निविदा सूचना के लिए शुद्धिपत्र /Corrigendum for Tender Notice

The date and time to submit a bid against this Institute's earlier published e-tender No. PS/128/01/2020 for Supply, Installation and Commissioning of 10 Porta Cabins of various sizes in to a cluster of office, laboratory and accommodation facility along with 3 toilet blocks (Turnkey Job), is extended as below:

No. PS/128/01/2020

Sub: Minutes of the Pre-bid meeting for Supply, Installation and Commissioning of 10 Porta Cabins of various sizes in to a cluster of office, laboratory and accommodation facility along with 3 toilet blocks (Turnkey Job)

Photo of the probable telescopic mast

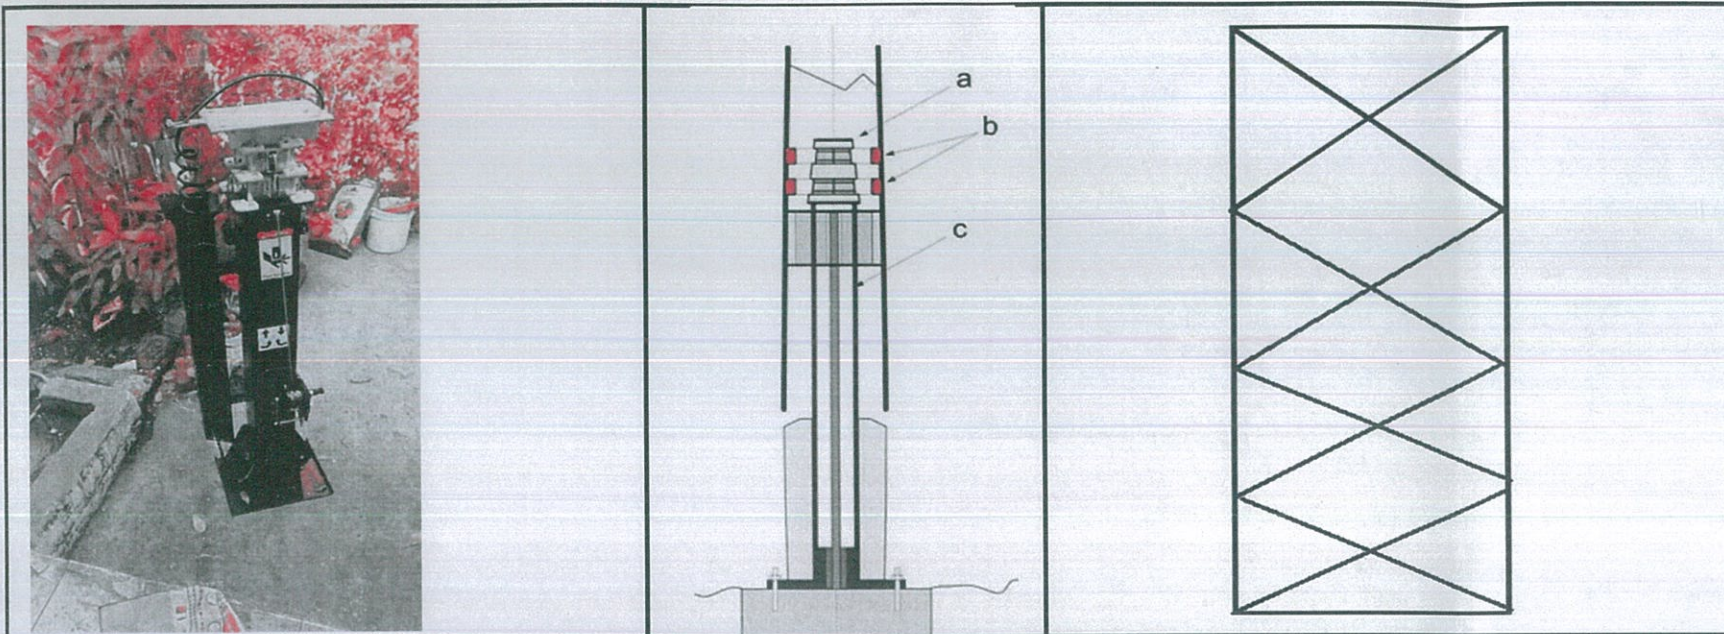
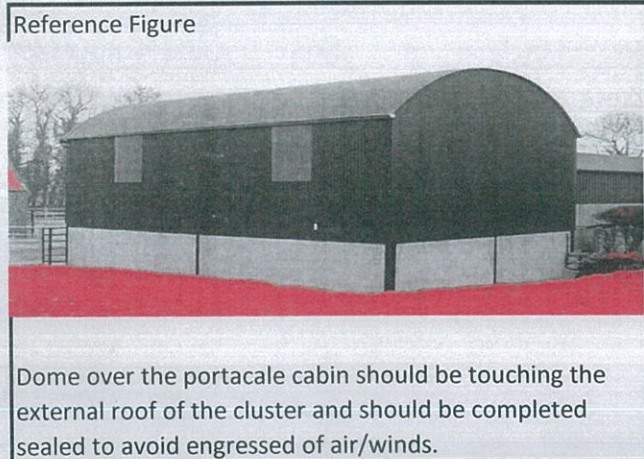
| 6 | What will be the location of the 10 mtr stack? What will be the size of the platform for it? Can you share G.A drawings,details and photographs of 10 mtr.stack? | | Figures are given below for clear understanding of concept of telescopic mast and cage for protection. |
| 7 | Can you share photographs,G.A drawings of the Telescopic/Linear Bar chimney? | | Yes, concept drawing and photograph are given below for reference |
| 1 | With referene bullet No. 4 on page no. 59, Supplier has to fabricate necessary platform and 10-meter stack to install various air inlets. | Further elaboration required from purchaser's end | Figures are given below for clear understanding of concept of telescopic mast and cage for protection. |

| 8 | With reference bullet No. 14 on page no. 72, TeleTelescopic linear Bar/ Chimney | Kindly elaborate further details/specifications required | Figures are given below for clear understanding of concept of telescopic mast and cage for protection. |

concept of telescopic mast and cage for protection height about 2.5 meters
